UNITED STATES PATENT AND TRADEMARK OFFICE

APPLICATION NO.	FILING DATE	FIRST NAMED INVENTOR	ATTORNEY DOCKET NO.	CONFIRMATION NO.
10/531,295	11/15/2005	Cristiano Casale	1034170-000028	6251

Office Action Summary	Application No. 10/531,295	Applicant(s) CASALE ET AL.	
	Examiner ELIZABETH VOLZ	Art Unit 3781

DETAILED ACTION

Figure 1 (Ramsey et al.)

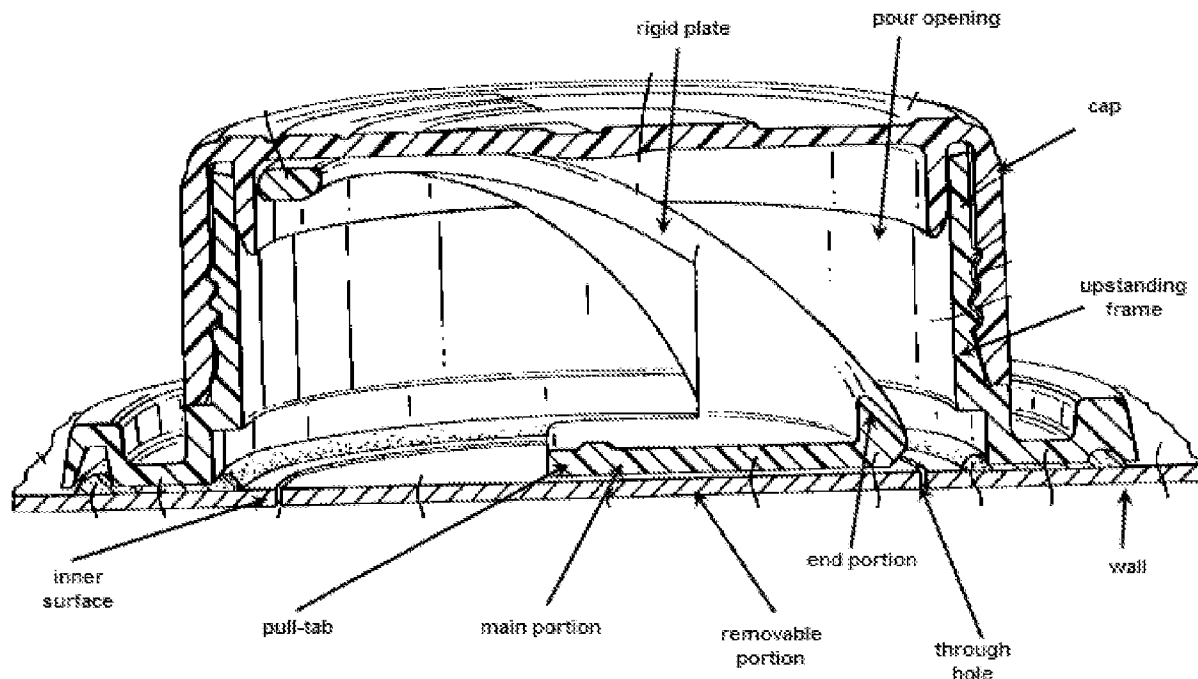
8. Regarding Claim 18, Ramsey et al. discloses a sealed package of pourable food product comprising: a plurality of walls (Figure 1 below); a through hole (Figure 1 below) passing through one of the walls; a removable portion (Figure 1 below) fixed directly to the one wall and completely covering the through hole; an upstanding frame (Figure 1 below) fixed to the package at a position surrounding the removable portion, the upstanding frame defining a pour opening (Figure 1 below) through which the pourable food product can flow when a part of the removable portion covering the through hole is removed; a cap (Figure 1 below) fitted to the frame and closing the pour opening, the cap being removable from the frame (Figure 1); a rigid plate (Figure 1 below) positioned in the upstanding frame and extractable from the frame by pulling action; a pull-tab (Figure 1 below) of sheet material attached to the rigid plate and attached to the removable portion, and the pull-tab of sheet material connecting the rigid plate to the removable portion so that pulling action applied to the rigid plate after removing the cap is applied to the removable portion by way of the pull-tab of sheet material to cause removal of the part of the removable portion (Figure 1).

9. Regarding Claim 21, Ramsey et al. discloses one wall which includes an exterior surface and an interior surface (Figure 1), the frame being tubular (Figure 1) and possessing an outer surface facing an inner surface of the cap (Figure 1), the tubular frame being fixed to the exterior surface of the one wall (Figure 1).

10. Regarding Claim 22, Ramsey et al. discloses a tubular frame (Figure 1 above) which does not pass through the through hole in the one wall (Figure 1).

11. Regarding Claim 23, Ramsey et al. discloses a removable portion which is fixed to the inner surface of the one wall (Figure 1 above).

12. Regarding Claim 24, Ramsey et al. discloses one wall which includes an exterior surface and an interior surface, and the removable portion is fixed to the inner surface of the one wall (Figure 1 above).

13. Regarding Claims 25 and 26, Ramsey et al. discloses a removable portion which is sealed to an edge of the through hole (Figure 1 above).

16. Regarding Claim 19, Ramsey et al. discloses a pull-tab which has a main portion (Figure 1 above) and an end portion (Figure 1 above), the main portion being attached to the removable portion and the end portion being attached to the rigid plate (Figure 1). Ramsey et al. does not disclose an end portion folded back onto the main portion. However, Hardt teaches a pull-tab which comprises an end portion 6 (Figure 1) folded over a main portion 5 (Figure 1). Therefore, it would have been obvious for one of ordinary skill in the art at the time the invention was made to modify Ramsey et al. to include a folded portion, as taught by Hardt, in order to allow the pull-tab to be removed easier.

20. Regarding Claim 27, Ramsey et al. discloses a sealed package of pourable food product comprising: a plurality of walls (Figure 1 above); a through hole (Figure 1 above) passing through one of the walls; a removable portion (Figure 1 above) fixed to the one wall and completely covering the through hole; an upstanding frame (Figure 1 above) fixed to the package at a position surrounding the removable portion, the upstanding frame defining a pour opening (Figure 1 above) through which the pourable food product can flow when a part of the removable portion covering the through hole is removed; a cap (Figure 1 above) fitted to the frame and closing the pour opening, the cap being removable from the frame; a rigid plate (Figure 1 above) positioned in the upstanding frame and extractable from the frame by pulling action; a pull-tab (Figure 1 above) of sheet material attached to the rigid plate and attached to the removable portion; and the pull-tab of sheet material connecting the rigid plate to the removable portion so that pulling action applied to the rigid plate after removing the cap is applied to the removable portion by way of the pull-tab of sheet material to cause removal of the

21. Regarding Claim 30, Ramsey et al. discloses one wall which includes an exterior surface and an interior surface (Figure 1), the frame being tubular (Figure 1) and possessing an outer surface facing an inner surface of the cap (Figure 1), the tubular frame being fixed to the exterior surface of the one wall (Figure 1).

22. Regarding Claim 31, Ramsey et al. discloses a tubular frame (Figure 1 above) which does not pass through the through hole in the one wall (Figure 1 above).

23. Regarding Claim 32, Ramsey et al. discloses a removable portion which is fixed to the inner surface of the one wall (Figure 1 above).

24. Regarding Claim 33, Ramsey et al. discloses one wall which includes an exterior surface and an interior surface, and the removable portion is fixed to the inner surface of the one wall (Figure 1 above).

25. Regarding Claims 34 and 35, Ramsey et al. discloses a removable portion which is sealed to an edge of the through hole (Figure 1 above).
